intel® Technical Advisory

TA-0739-01

November 23, 2004

Slim-line CDROM Drive Trays Stick when Opened

Slim-line CDROM assembly for fixed drive configurations

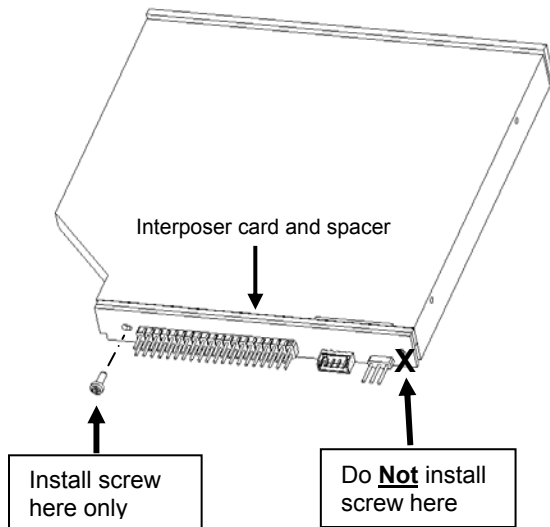
From shock and vibration test results, Intel has determined that the use of a single screw can be used to attach the interposer card and spacer to the slim-line CDROM drive. See Diagrams below.

Intel has included modified assembly instructions with each of the product revisions listed above that have a build date after November 24, 2004. Build dates can be found on the White Product Label affixed to the product's outer packaging. The modified assembly instructions will advise customers to use one screw to attach the interposer card and spacer to the slim-line CDROM drive.
